DR-216

## INSTALLATION GUIDE

## P/N 06510 REV K

## ADDENDUM TO DR-216 INSTALLATION GUIDE

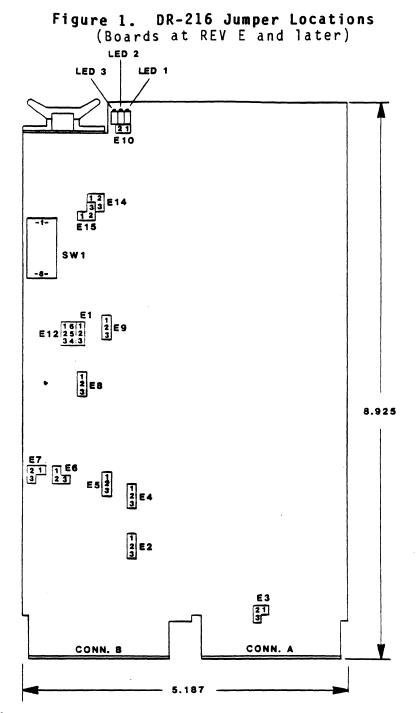
In certain system configurations, it is possible for the DR-216 memory module to short to the stiffener bar of the module below it causing system failure. Therefore, when installing the DR-216, verify that it does not contact the stiffener bar of the module below it. If contact does occur, move either the DR-216 or the other module to prevent possible system malfunction.
